Re: Durango at the Trails, Grading and Drainage Plan (C09/D012)

This letter provides a written response to your comments dated May 5, 2015:

DURANGO
UNIT 4
GRADING AND DRAINAGE PLAN

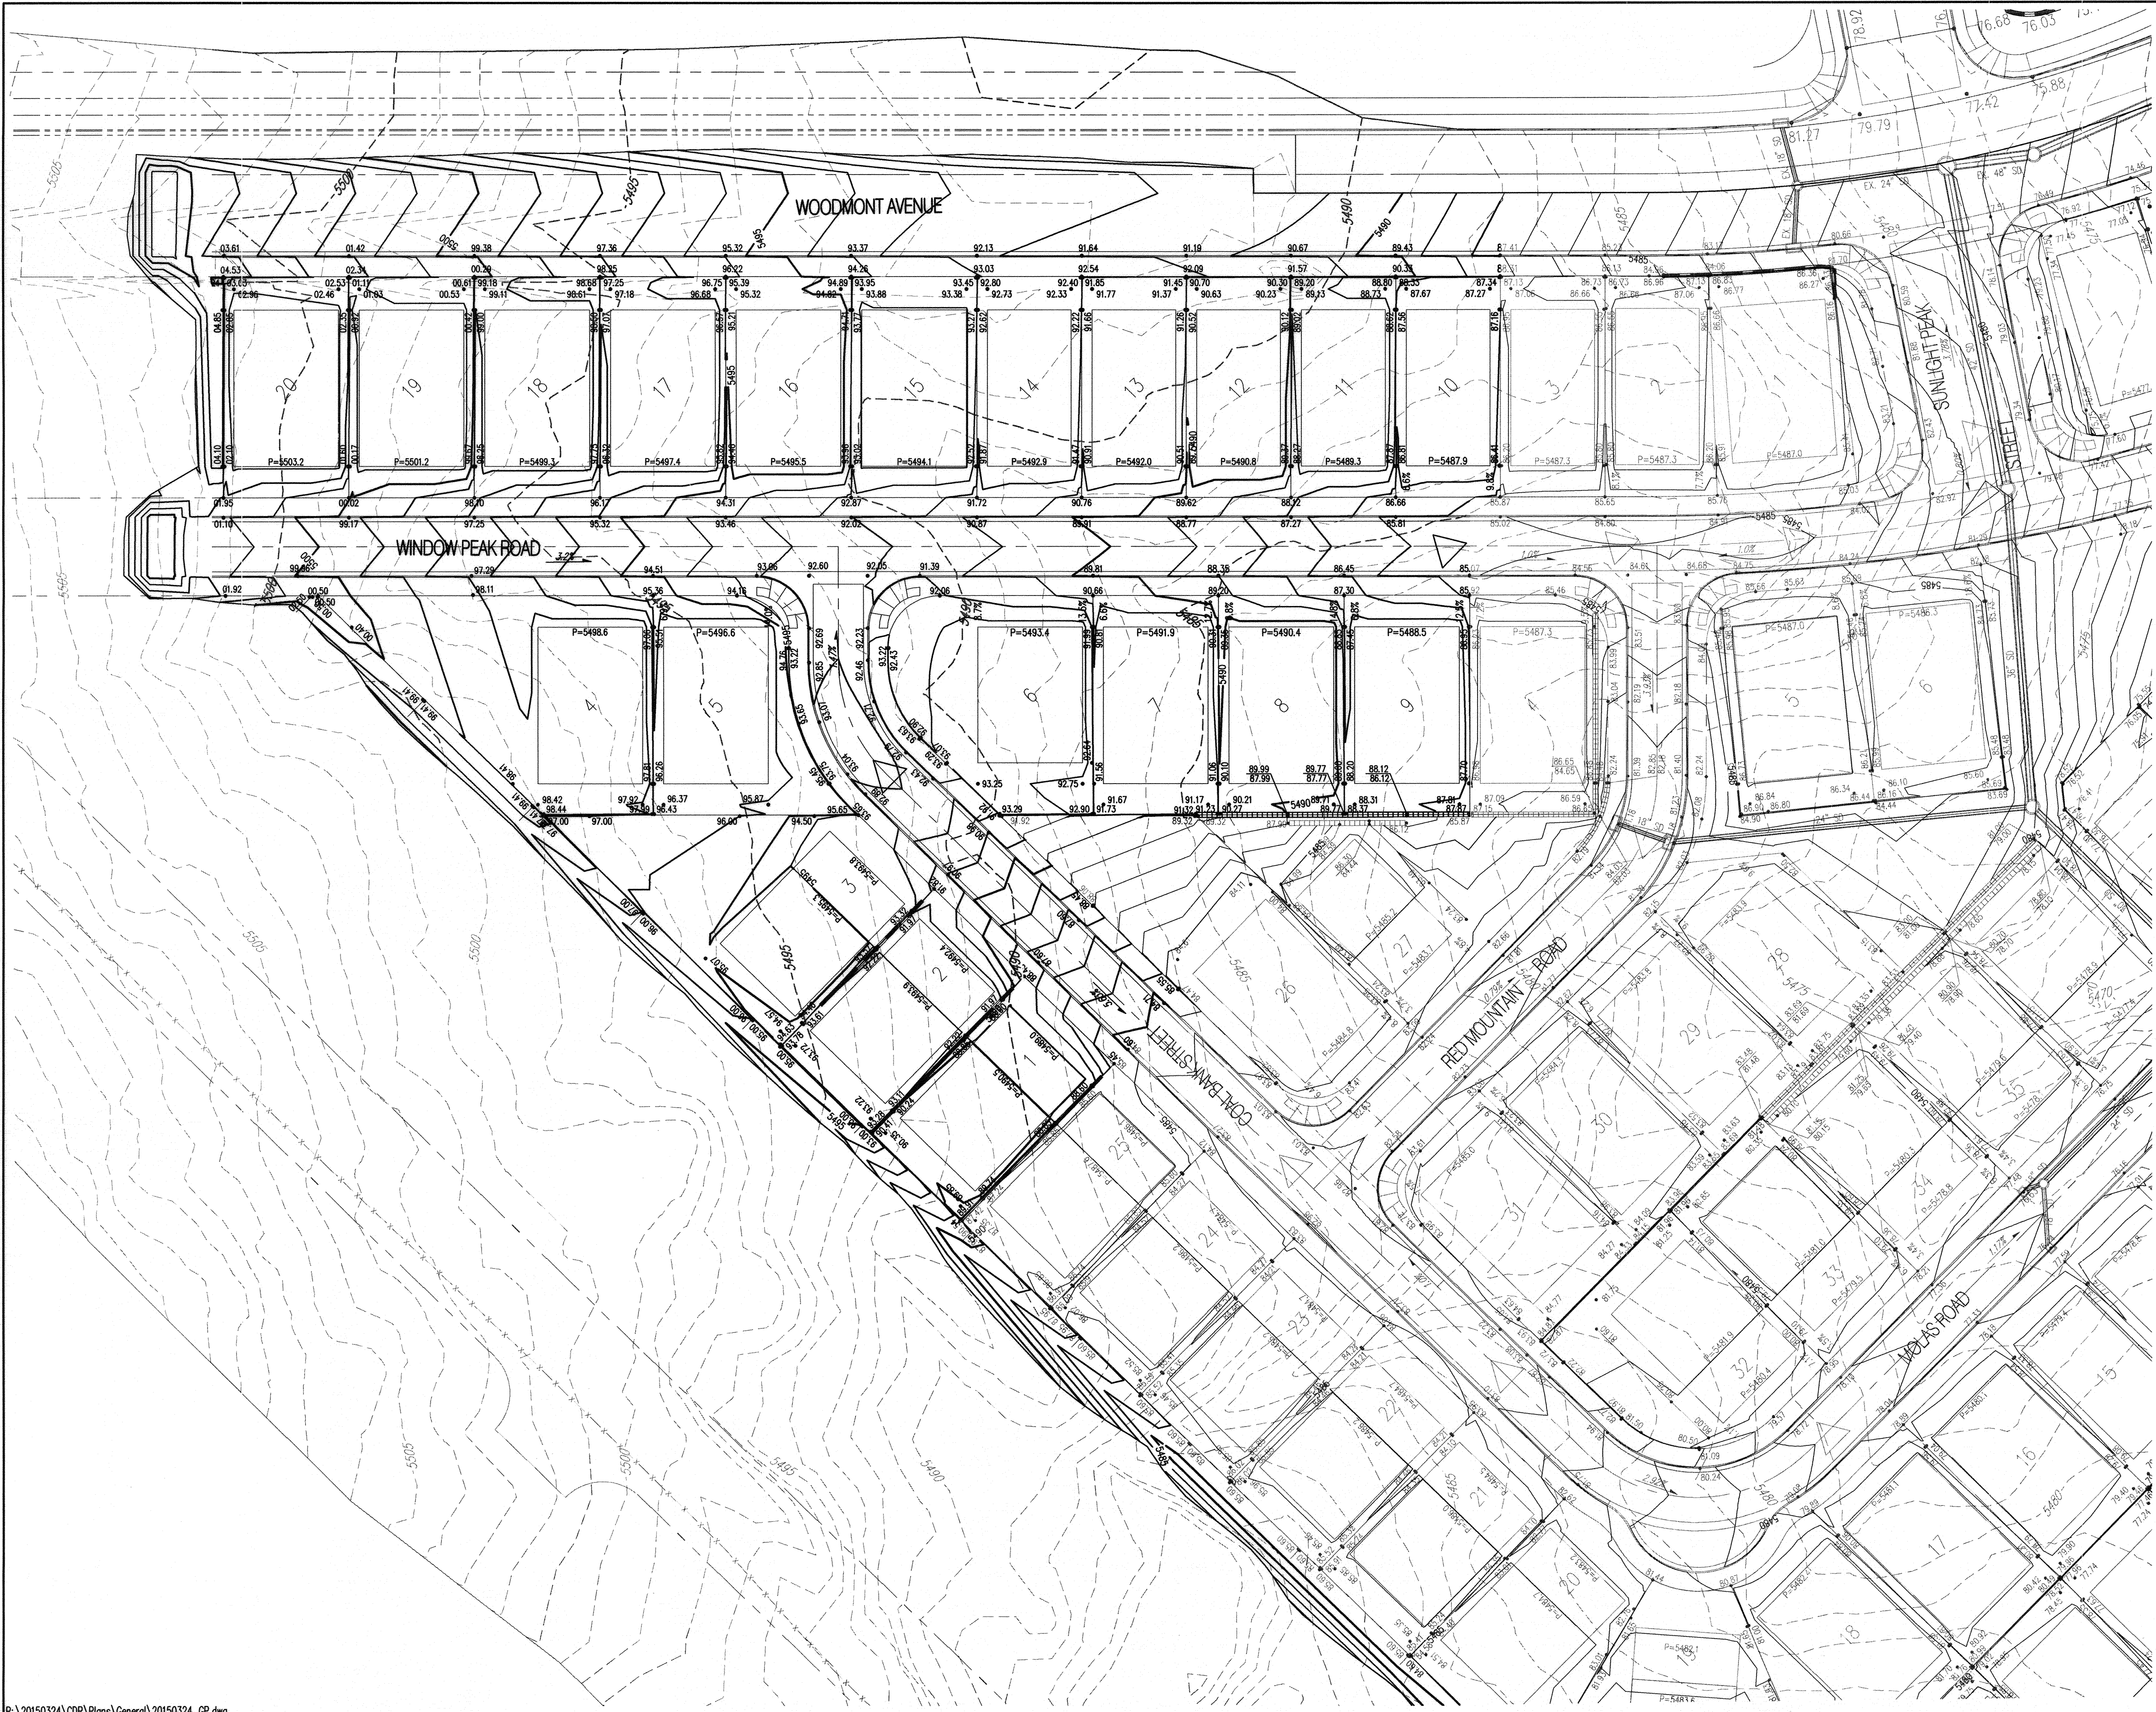
1. *Units 1 thru 4 are to be phased. Provide an interim grading plan for each phase, showing sediment ponds and tie slopes. **Interim grading plans are provided for Units 1 and 2. The tie slopes and sediment ponds for Units 3 and 4 are shown on the respective grading plans. At this point in time we are requesting preliminary plat approval of Units 1 and 2.***
2. *Provide revised grading plan showing recent changes. Grades and retaining walls will be checked after this plan is submitted. **Revised grading plan for Units 1 through 4 are provided.***
3. *Revise infrastructure list with separate line items for each run/size of pipe. **Infrastructure list has been revised per markup provided at 5/5/2015 meeting.***
